UNITED STATES PATENT AND TRADEMARK OFFICE

10/791,101

Office Action Summary	Application No. 10/791,101	Applicant(s) GOTTESFELD ET AL.	
	Examiner Gregg Cantelmo	Art Unit 1795

DETAILED ACTION

FIG. 4

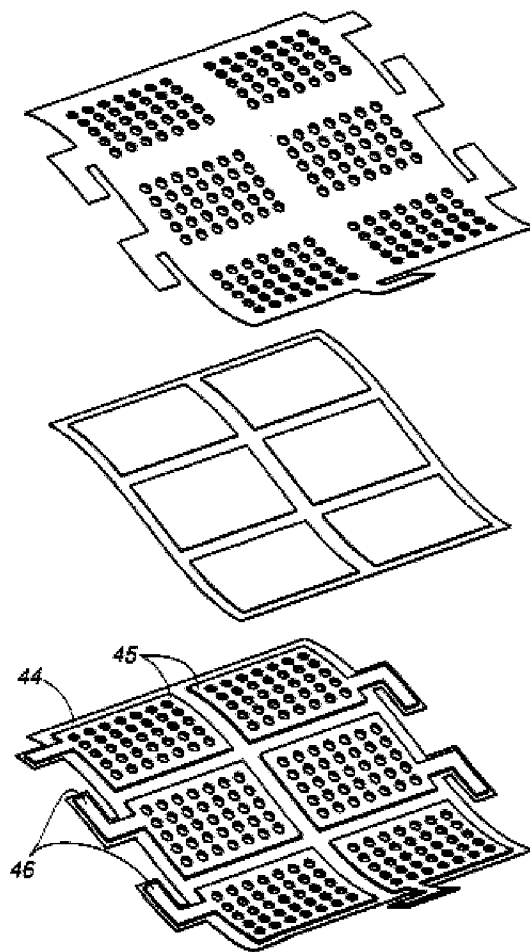
Pratt discloses a conformable fuel cell in Fig. 4, comprising: (A) a membrane electrolyte intimately interfacing with a catalyst layer along each of the membrane's major surfaces being a catalyzed membrane electrolyte, having an anode aspect and a cathode aspect, and which catalyzed membrane electrolyte is flexible (e.g., conformable to a desired shape); (B) diffusion layers sandwiching said catalyzed membrane

electrolyte, said diffusion layers being comprised of materials that are conformable; (C) flexible current collectors coupled with each of said anode aspect and said cathode aspect of said membrane electrolyte; (D) fuel delivery means coupled with said anode aspect of said membrane electrolyte that delivers fuel substantially uniformly to said anode aspect while said fuel cell maintains said desired shape (Figs. 2-5); (E) electrical coupling 45 disposed across said anode aspect and said cathode aspect and having means for connection to an application device being powered by said fuel cell (as applied to claim 1).

The housing shown in Figs. 3 and 4 is constructed and conformed to a desired contour, in this case a planar contour. This interpretation is a reasonable interpretation in light of the Applications own definition of the term conformable (see page 11, ll. 15-19 of the specification).

The current collectors 45 at each of said anode aspect and said cathode aspect apply “adequate compression” effectively over the active area of the membrane electrolyte of each cell (Fig. 4 as applied to claim 2)
